Circular No. 229 / 2023

Field Safety Corrective Action of Cios VA30 from Siemens Medical Solutions.

Customer Safety Information (CSI) for Field Safety Corrective Action

Subject: Fulfillment of new requirements from DIN and IEC standards for Cios VA30 Systems

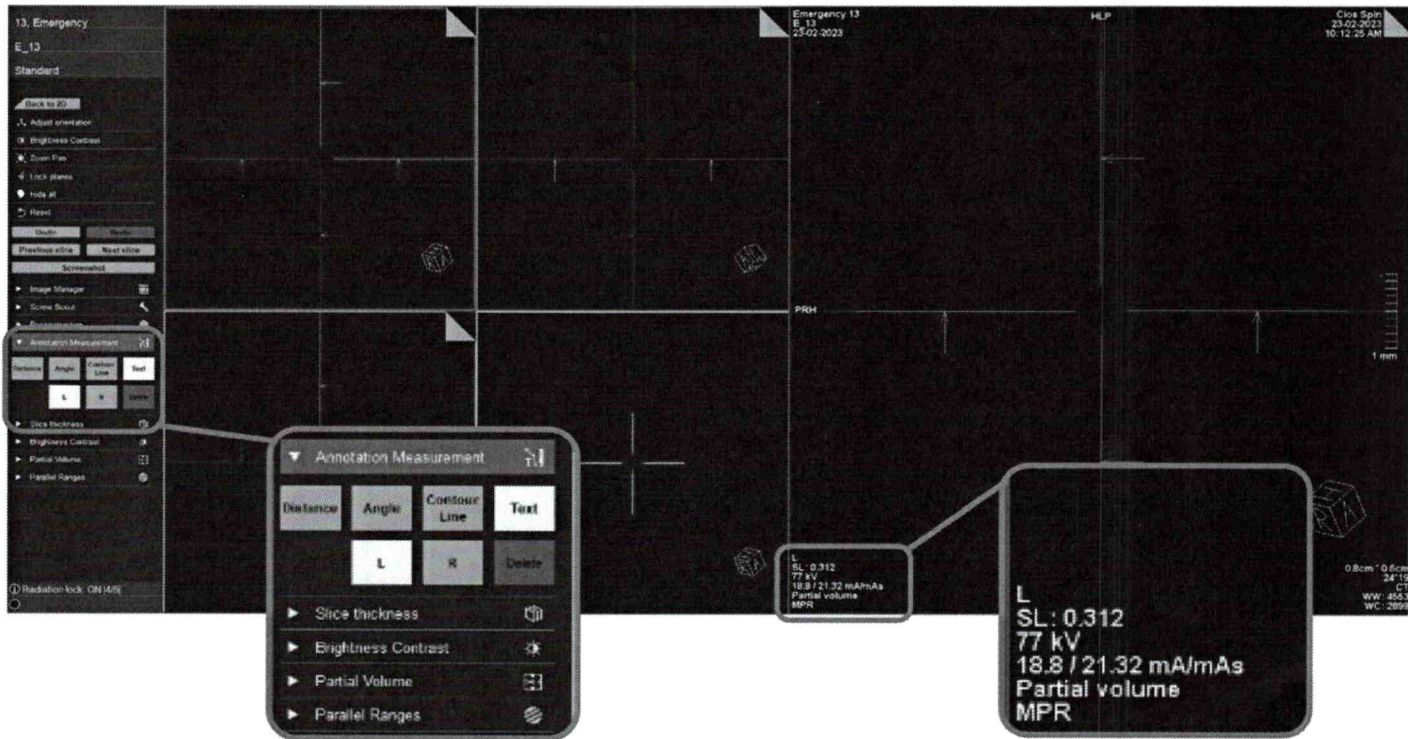
With respect to DIN 6862-3:

In 3D mode and if patient orientation information is important in a procedure, the user can predefine the patient orientation "L/R" (left/right), and therefore "laterality" information will additionally be saved in the clinical image (see screenshot of user interface below).

With respect to IEC 60601-2-54:

In radiography modes SUB, DR, DCM as well as in 3D mode, the autostore function is selected/activated by default and cannot be deactivated by the user.

Our service organization will install a new software version VA30K.

With software version VA30K, the user interface of Cios VA30 systems will be changed to consider the current standards DIN 6862-3 and IEC 60601-2-54.
